**September 2, 2004 NYSDEC Comment
Letter**

The New York State Department of Environmental Conservation (NYSDEC) has reviewed the "Remedial Design Work Plan - Overburden Soil Remedy," prepared by Blasland, Bouck and Lee and provided by the General Electric Company (GE) to NYSDEC on July 30, 2004.

Re: Remedial Design Work Plan,
Overburden Portion of Remedy
Hudson Falls Record of Decision, Site No. 5-58-013
Response to NYSDEC letter of September 2, 2004

Figure 1

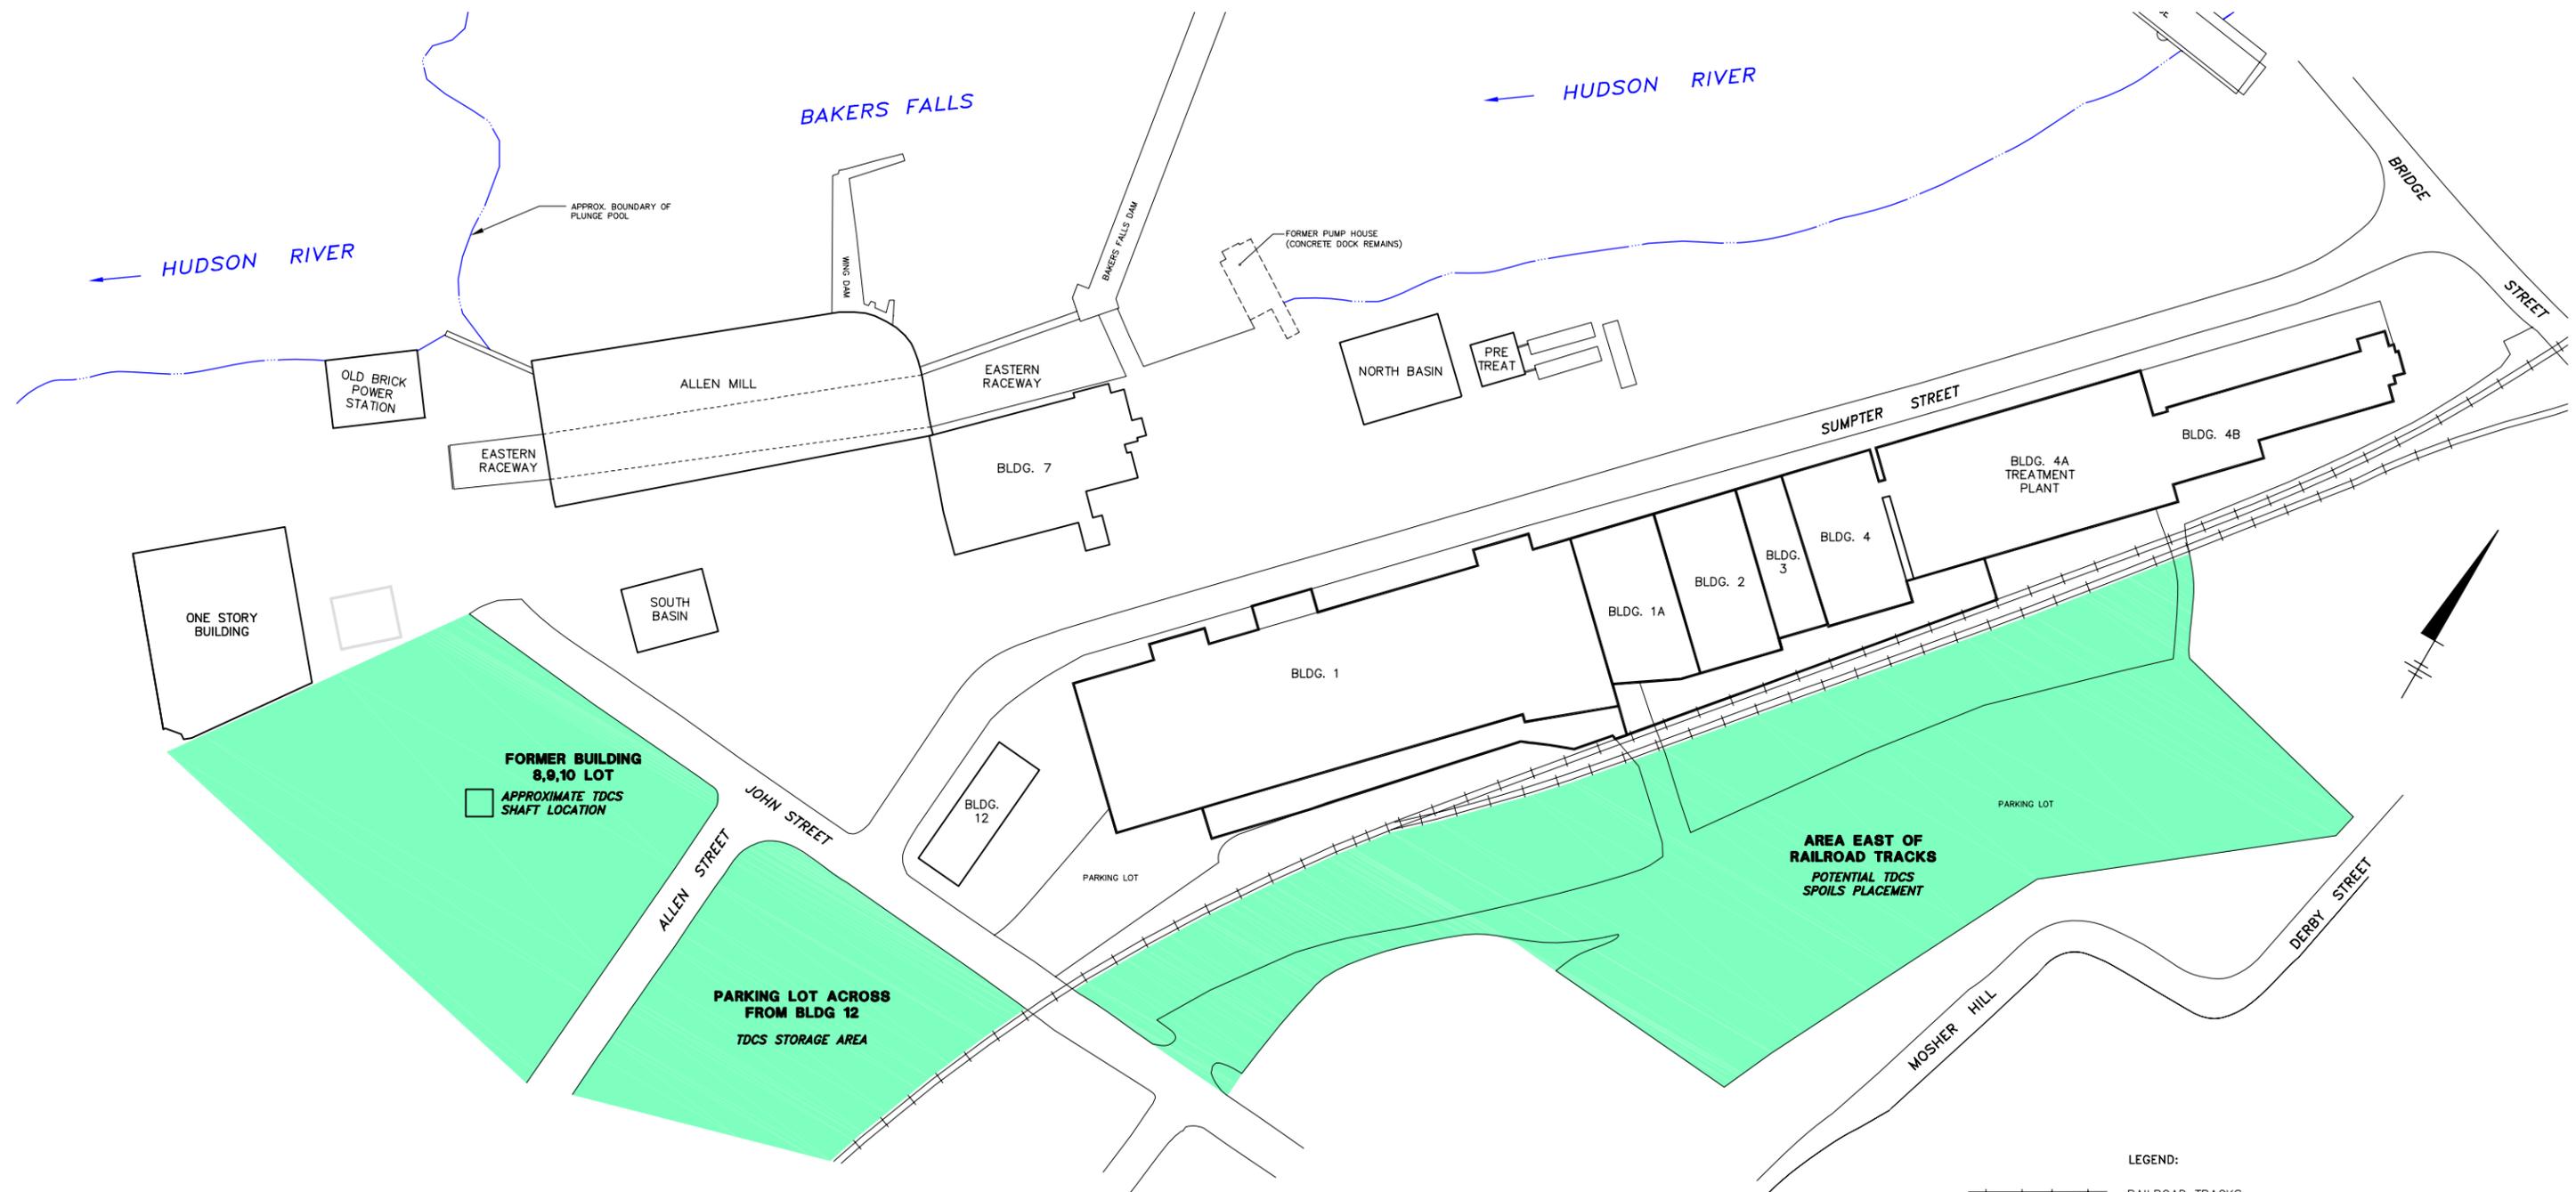
2) The proposed sequencing/phasing of the remedial design may be unnecessarily complex; by combining discrete elements, a more efficient design work plan can be developed. NYSDEC believes that several of the discrete steps in the RDWP can be combined to accelerate completion of the design.

3) This RDWP should acknowledge that the ongoing design and implementation of the remedial program from Operable Units 2B, 2C, and 2D at the site will need to be taken into account to ensure that the two elements of the remedial program for the site do not cause logistical, scheduling, or other conflicts.

4) The schedule is much longer than anticipated by NYSDEC. In previous meetings on this issue between NYSDEC and GE, a design duration on the order of two years was discussed. NYSDEC estimates that it may take five to six years for completion of the remedial design as currently

proposed; however, if the phasing of the RDWP is modified as discussed above, the schedule can be reduced significantly. NYSDEC envisions a design schedule, including technology testing, with a duration of approximately two or three years.

In to order prevent logistical and scheduling conflicts with the construction of the TDCS, GE and its consultants will accelerate and complete the Remedial Design process for key areas of the site. As shown on Figure 1, the former Building 8,9,10 lot, the parking lot across John Street from Building 12, and the area east of the railroad tracks will be addressed in parallel with the Final Design for the TDCS which is due 8/1/05.

The Final Designs for the TDCS, the former Building 8,9,10 lot, the parking lot across John Street from Building 12, and the area east of the railroad tracks are related and will be addressed accordingly. The staging, excavation, and final placement of the rock spoils from the TDCS will be specified in detail in the Final Design. An integrated remedy and construction schedule will be required for these areas of the site. In total, the former Building 8,9,10 lot, the parking lot across John Street from Building 12, and the area east of the railroad track represent approximately 38% of the total area of the site.
